DE LOREAN MOTOR COMPANY

SERVICE BULLETIN

NUMBER ST-18-10/81

SUBJECT: VENT HOSE - CONTROL PRESSURE REGULATOR

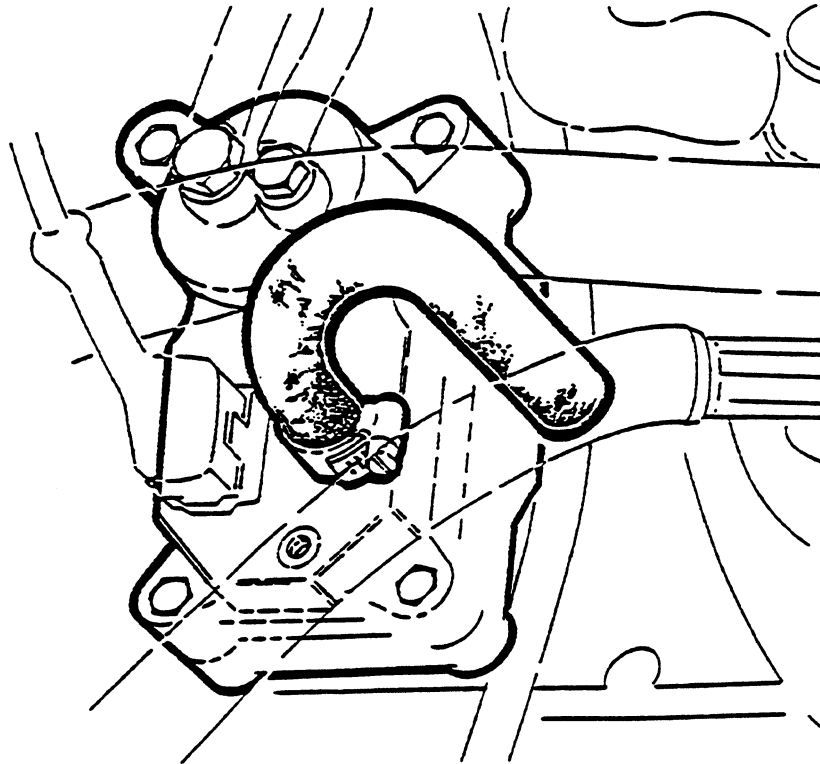
The installation position of the vent hose on the control pressure regulator should be inspected and corrected on all DMC vehicles up to V.I.N. 2283, as well as on all DMC vehicles during service visits.

If necessary, to prevent kinking the vent hose should be rotated away from the air conditioning hose. (See Illustration)
